URGENT MEDICAL DEVICE CORRECTION

GEHC Ref# 36127A

RE: CARESCAPE B450, B650, and B850 (Bx50) monitors may restart due to network overload situation caused by network misconfiguration

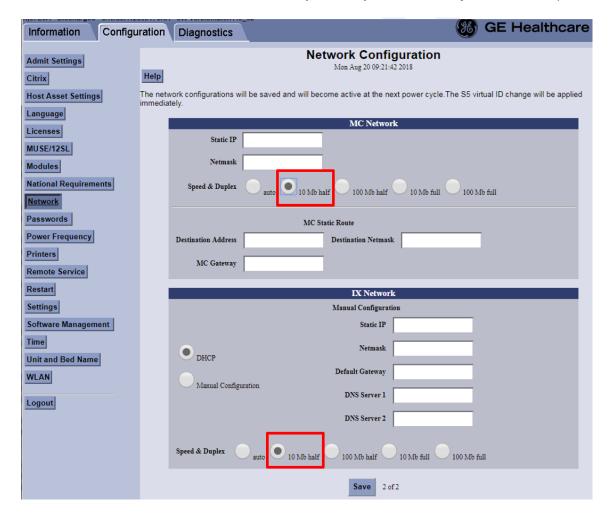
- 1.Turn On the monitor.
- 2. Log in to Webmin service interface.
 - Select Monitor Setup > Service.
 - NOTE: Webmin user interface is in English only.
 - In the Login to Webmin dialog box, type the username and the default password as below, or the password set by user:

Username: biomed Password: Change Me
